Project No. 1575.01
August 29, 2017

Subject: Geotechnical Report Addendum
Proposed Kirkland Rairdon Improvements
13110 NE 126th Place
Kirkland, Washington

The purpose of this letter is to provide an addendum to our previously-issued preliminary geotechnical report (Phase 1 Geotechnical Report, Proposed Kirkland Rairdon Improvements, 13110 NE 126th Place, Kirkland, Washington) dated December 2, 2016 (Previous Report). Our previous report described an apparently unstable bare soil escarpment located at the toe of a ridge feature to the north of the proposed improvement area. Our Previous Report presented a conceptual alternative to stabilize the escarpment utilizing a quarry spall buttress.

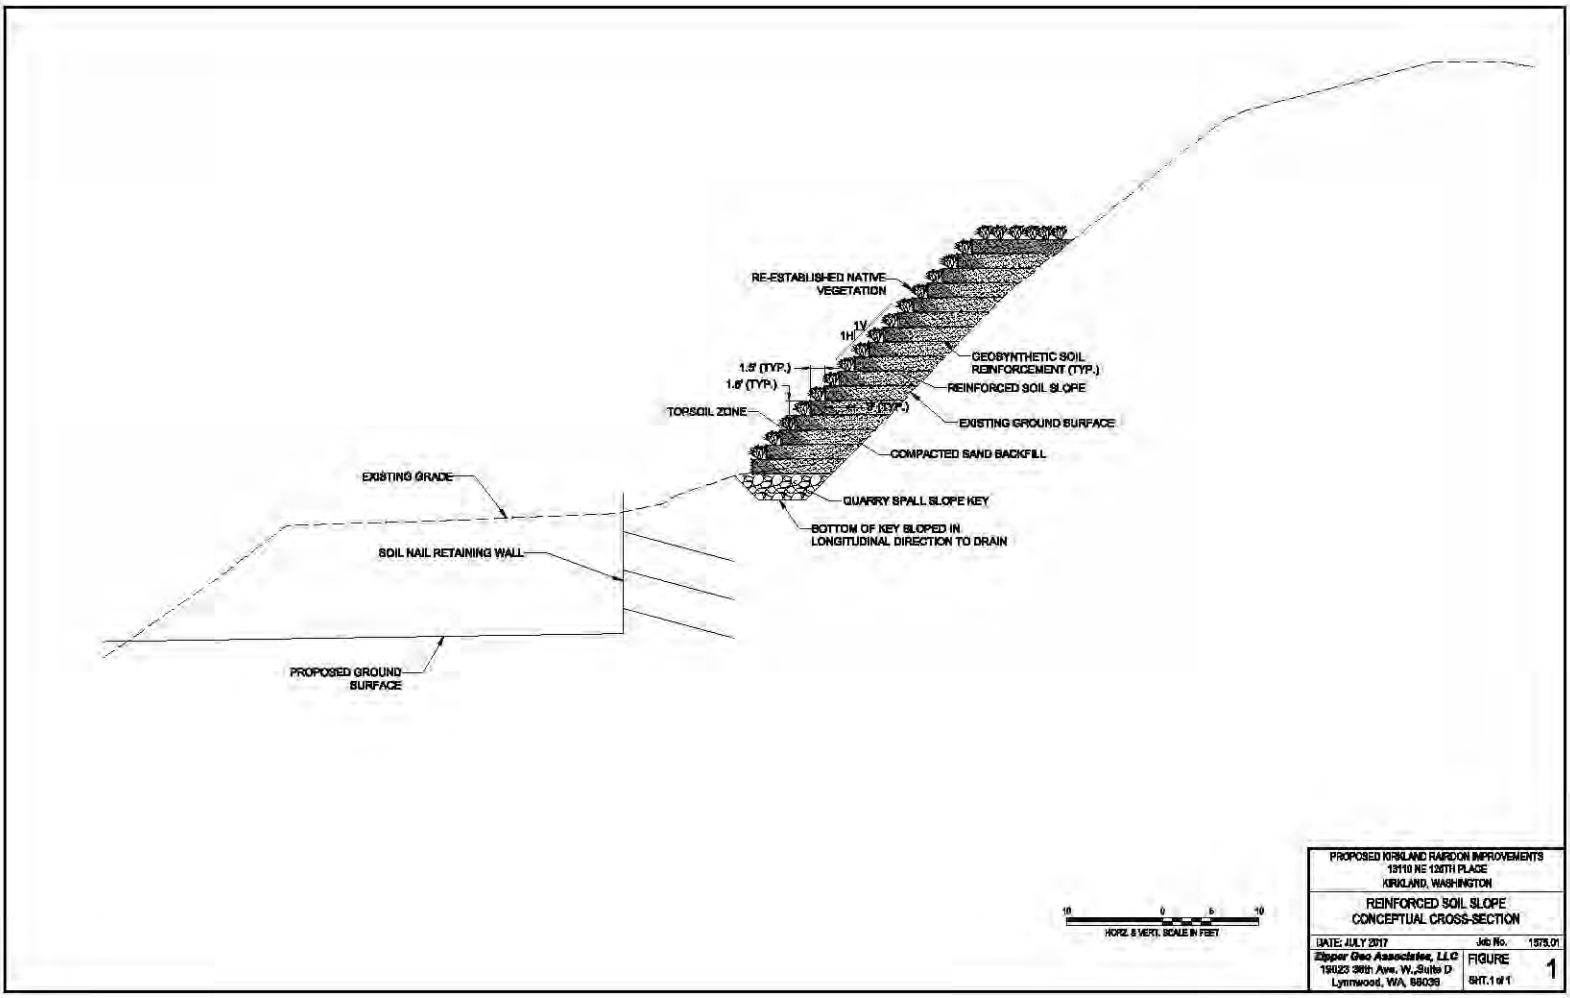
We understand the City of Kirkland has voiced concern regarding successfully establishing permanent vegetation on the quarry spall buttress. As an alternative to the quarry spall buttress, it is our opinion that a reinforced soil slope could be constructed to stabilize the escarpment. With a reinforced soil slope, the entire slope would be constructed of "soil", thereby increasing the probability of establishing healthy, permanent vegetation on the slope. A conceptual cross-section of the reinforced soil slope is provided in the attached Figure 1. If approved, design details for the reinforced soil slope will be provided as part of our final geotechnical report for the project.
